STAFF REPORT
KETCHUM PLANNING AND ZONING COMMISSION
MEETING OF APRIL 23rd, 2024

PROJECT: Warm Springs Preserve Building

FILE NUMBER: P23-104

APPLICATION: Design Review

EXTERIOR ELEVATIONS

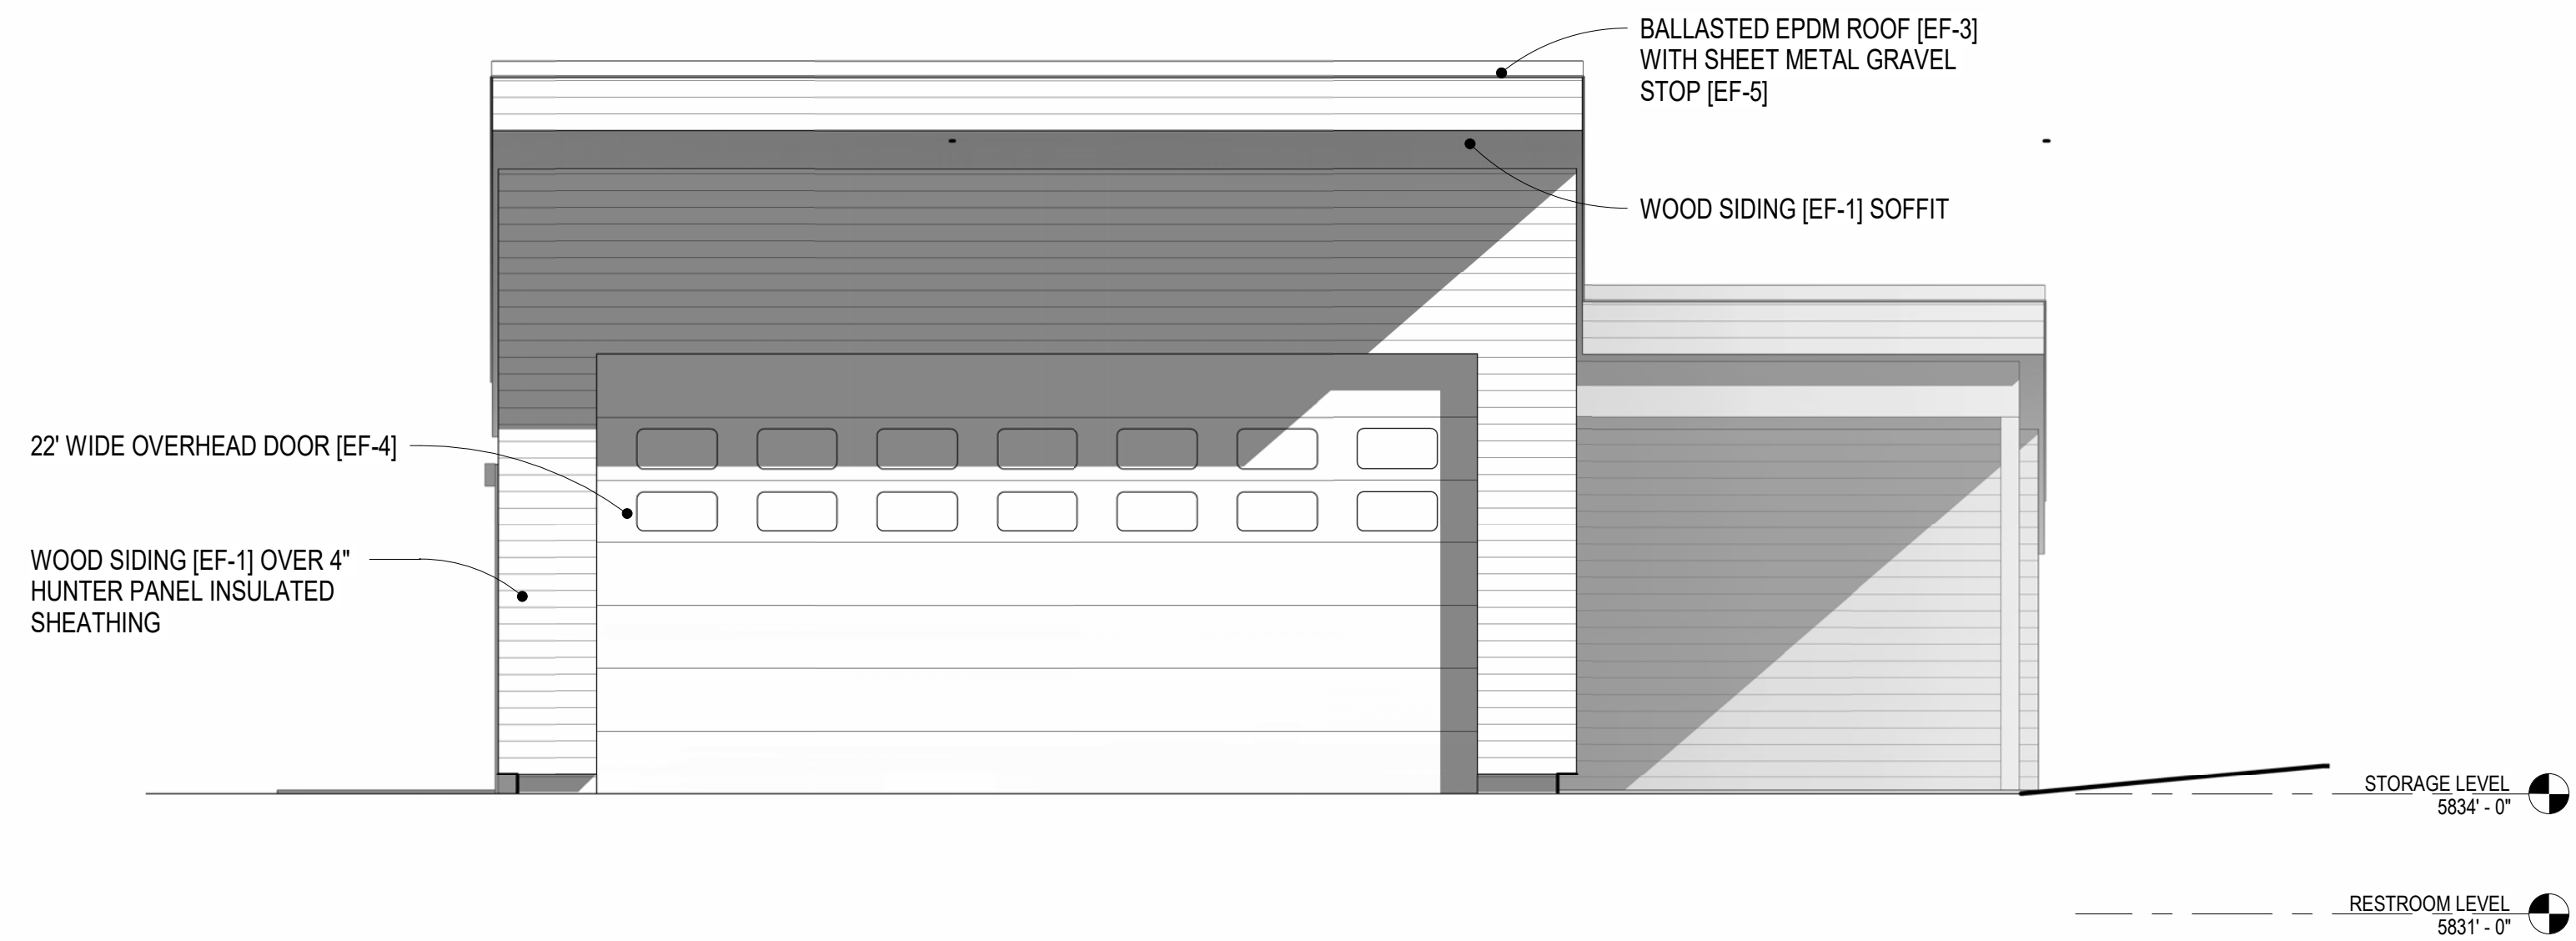
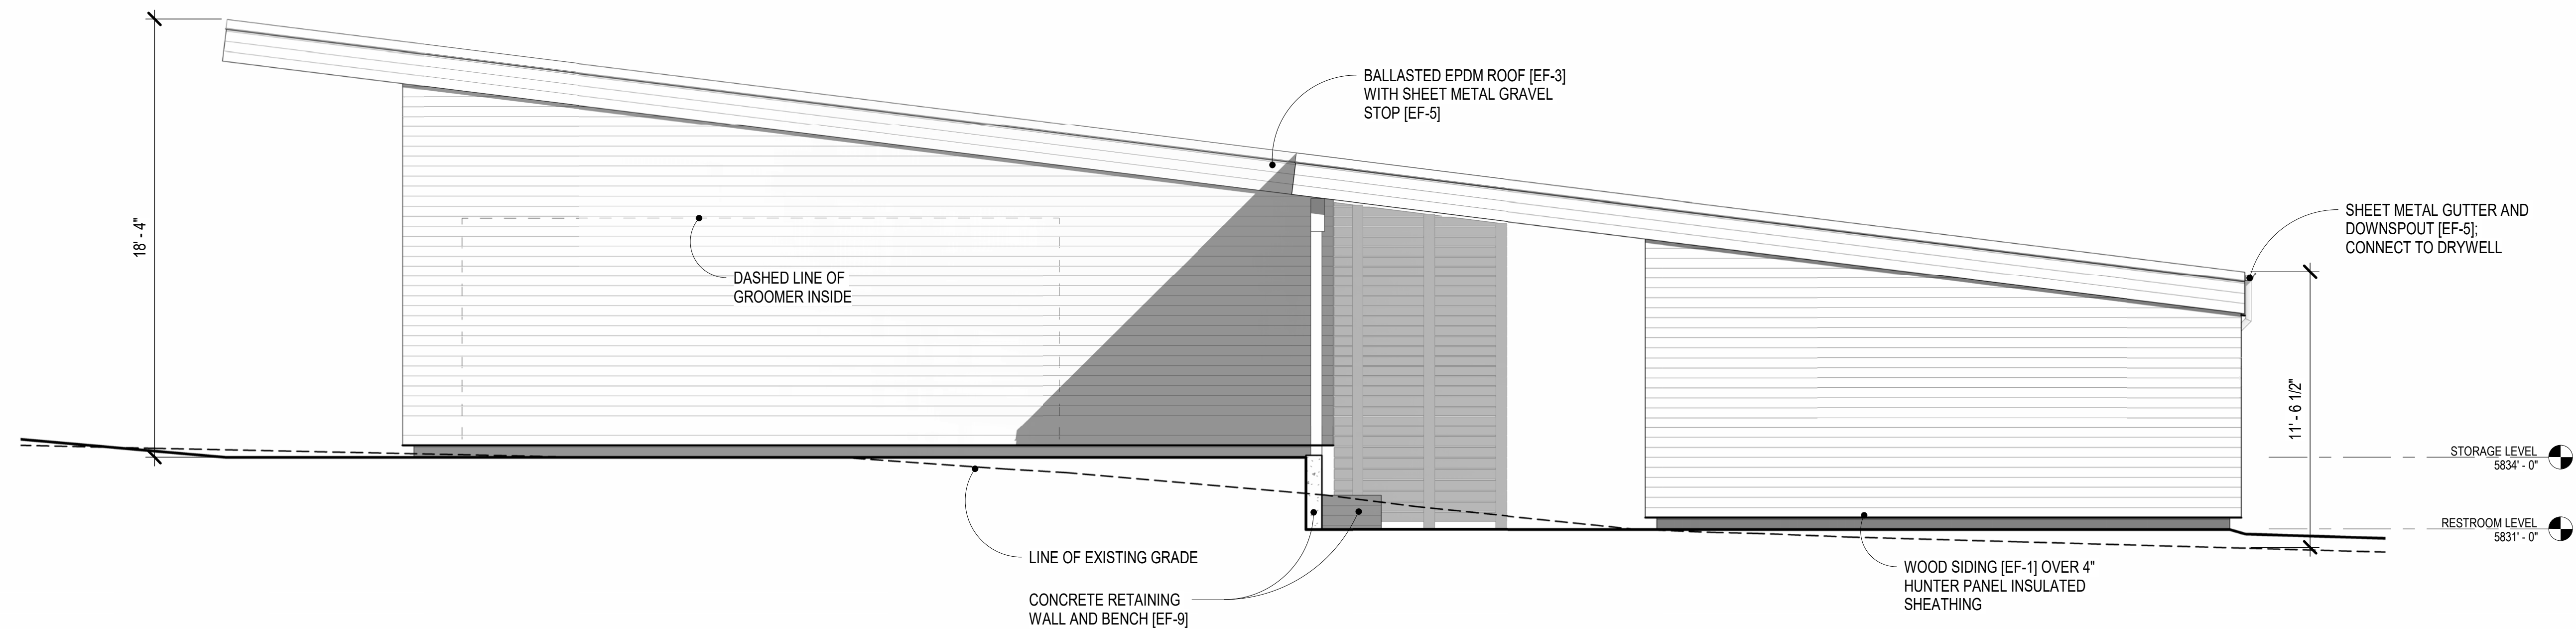
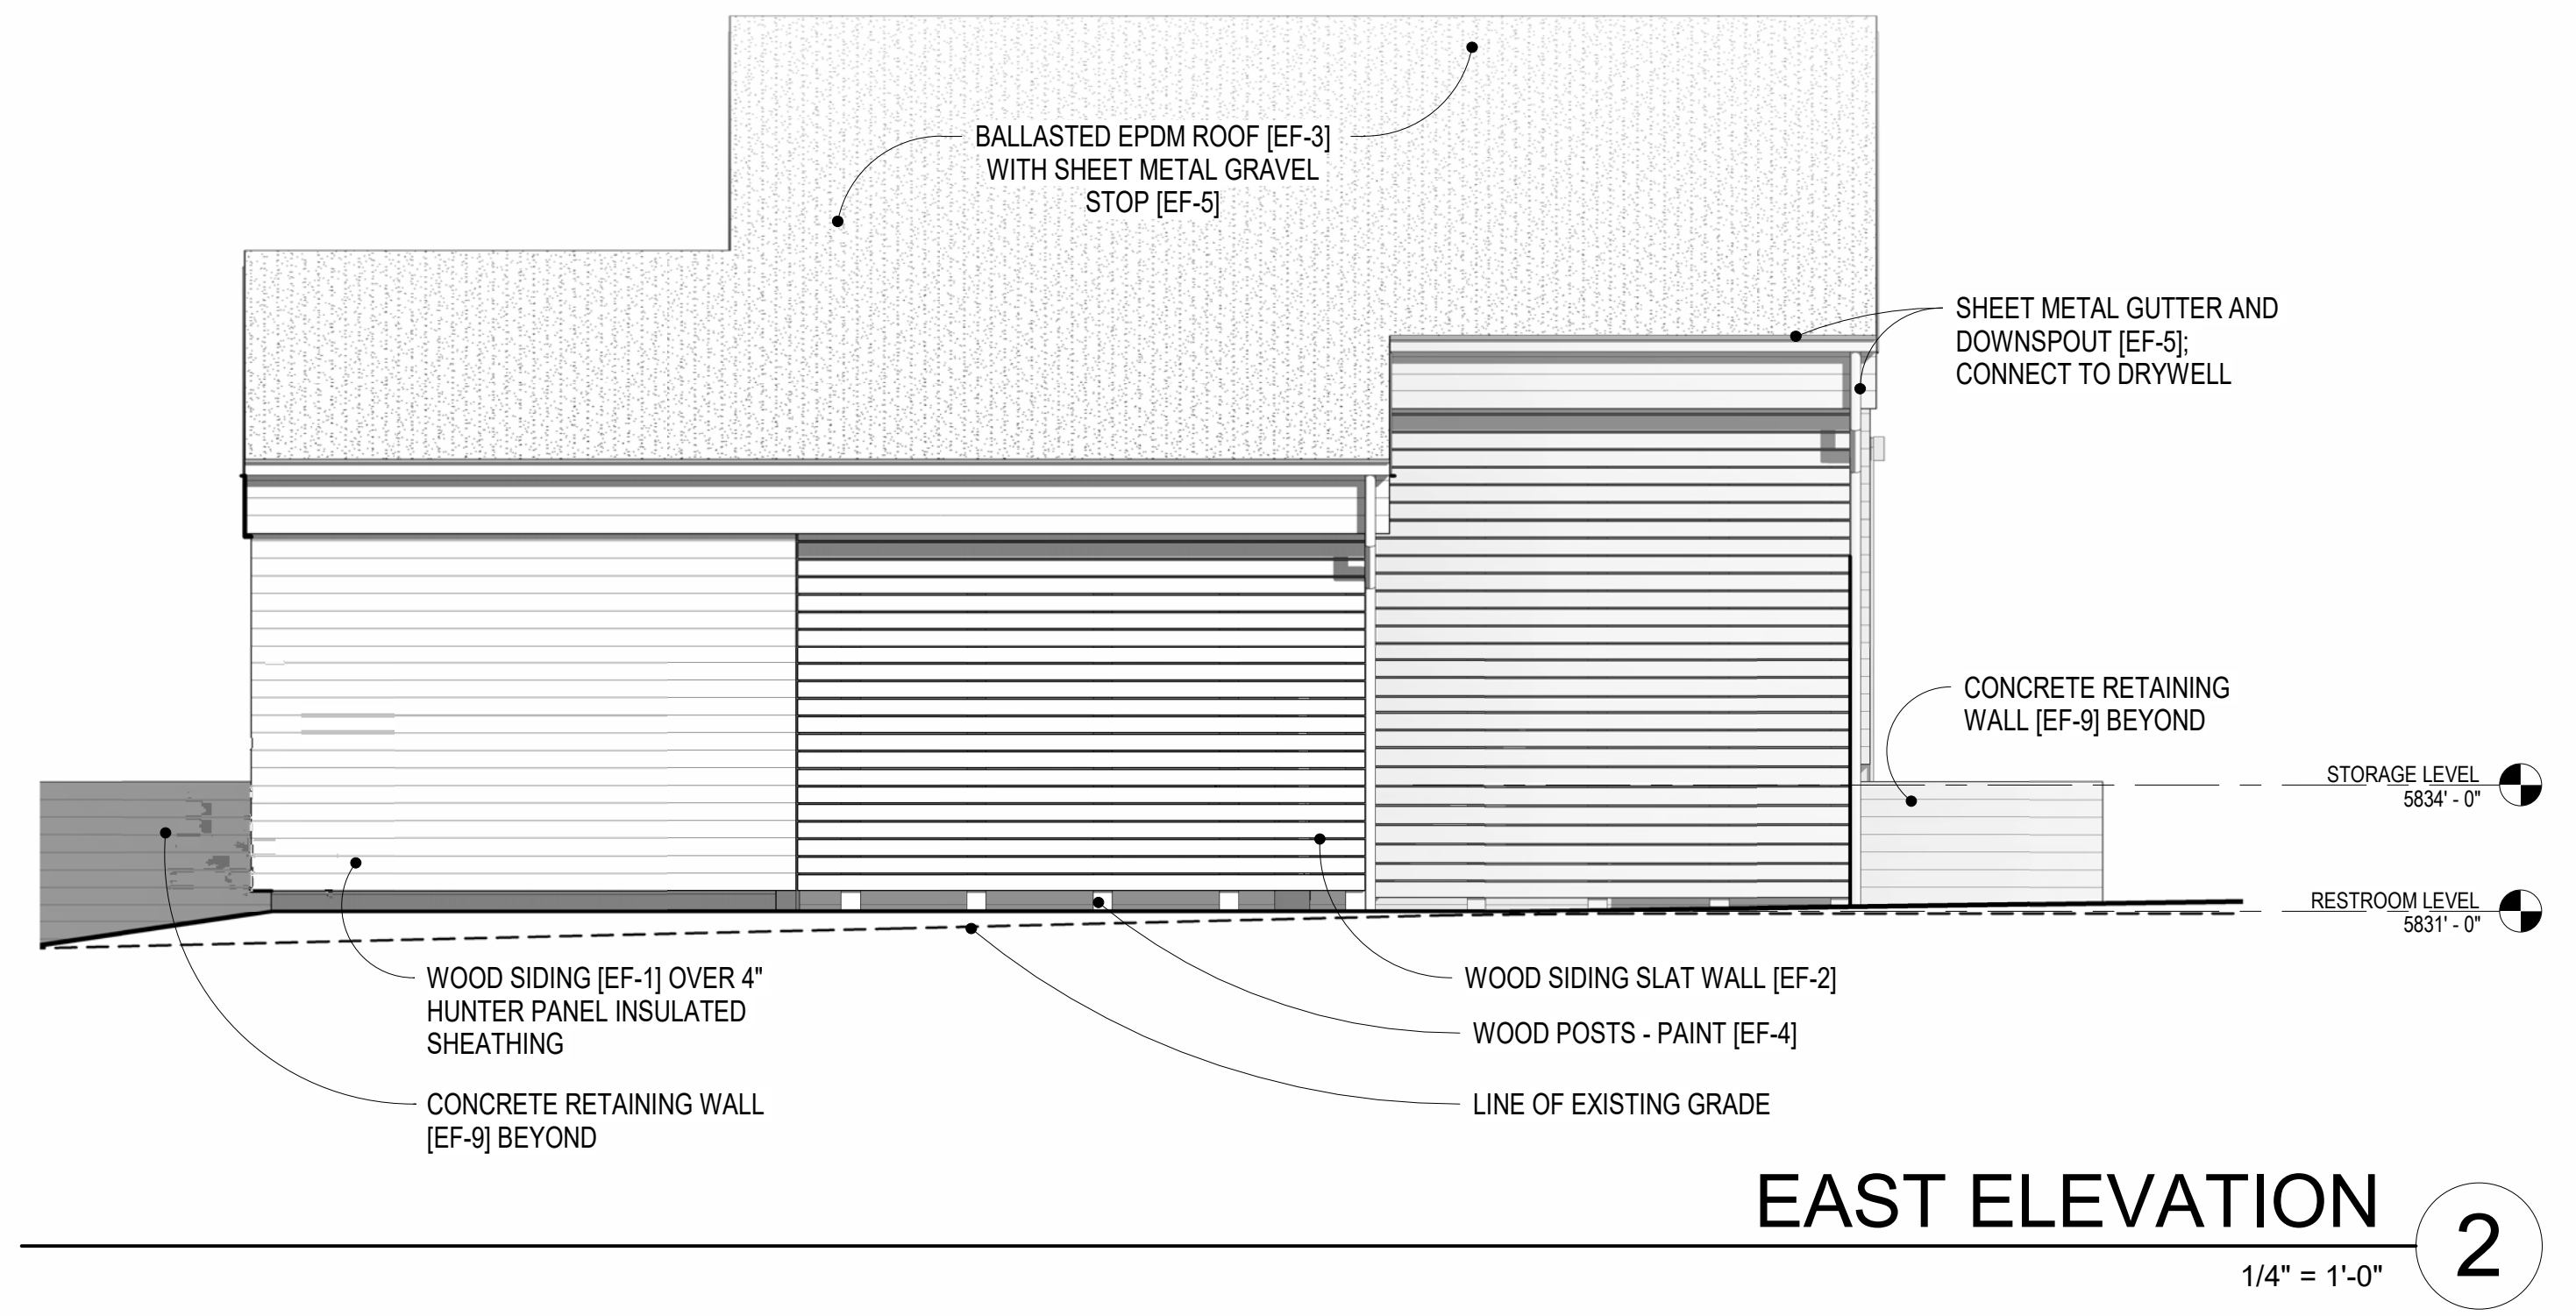
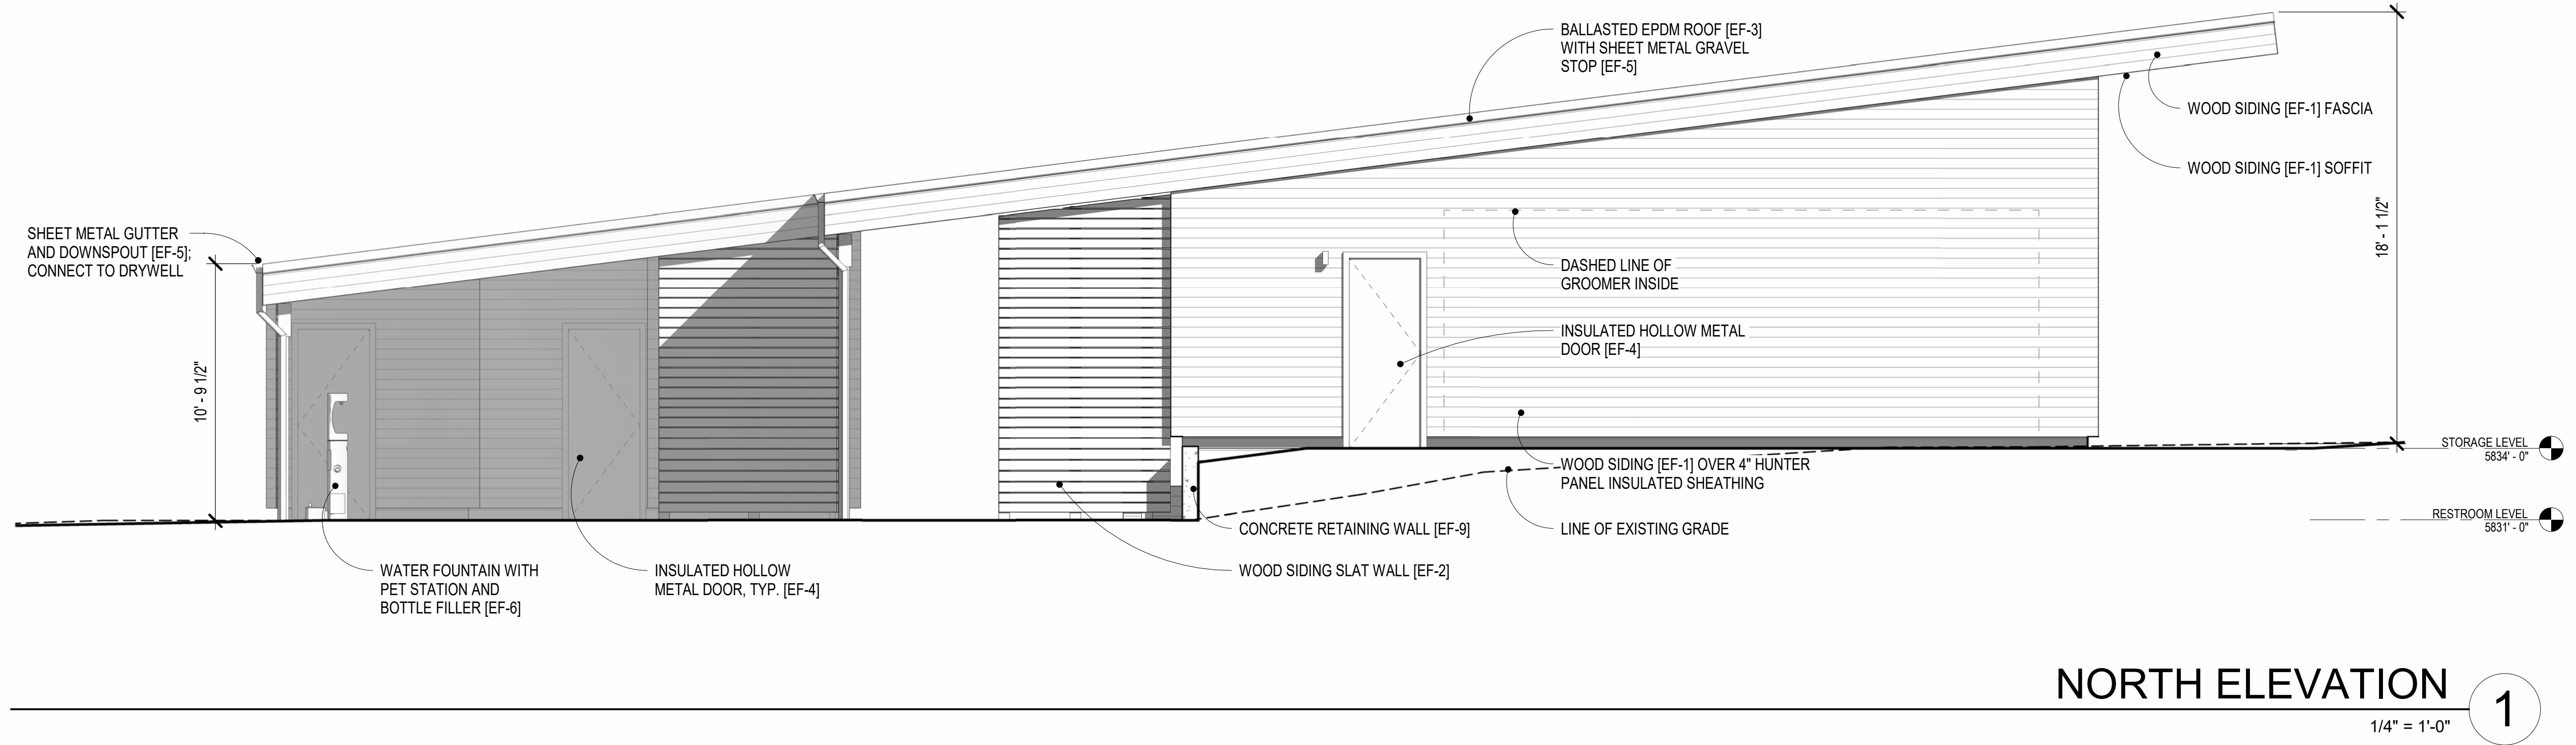
| 17.96.060.F.4 – Architectural | Conformance |
|--|-------------|
| Finding: The proposed trash enclosure looks to use the same materials as the building (either wood or metal). A 3ft board form concrete wall is proposed on the downhill side of the storage room and matches the wood siding well in staff’s review. Landscaping is primarily native and will be planted all around the structure. | |
